Contribution to IEEE Draft P802.17-D2.0

Time-to-live return path updates

The current RPR 2.0 draft has potential deadlock problems associated with respect to return-path timeToLive updates. This contribution fixes that potential concern.

Figure F.2—Wrapped *timeToLive* aging

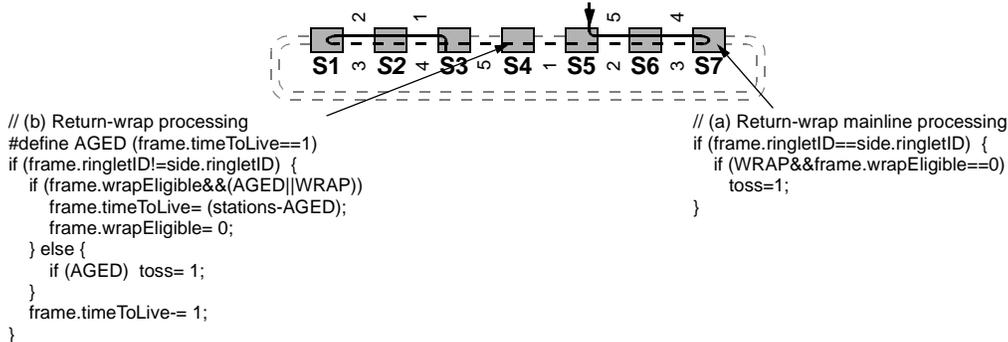
On a wrapped ring, only *wrapEligible*=1 frames (a) are wrapped, as illustrated in Figure F.2. The *timeToLive* value is supplemented and the *wrapEligible* bit is cleared (b) when reaching the timeout or rewrap station.

The *timeToLive* supplement is based on the estimated number of wrap-back stations, with the following assumptions:

- a) Edges. Edge stations decrement *timeToLive* by one (not two), even for edge-wrap configurations.
- b) Postprocess. The *timeToLive* decrement occurs always, including after *timeToLive* compensation.
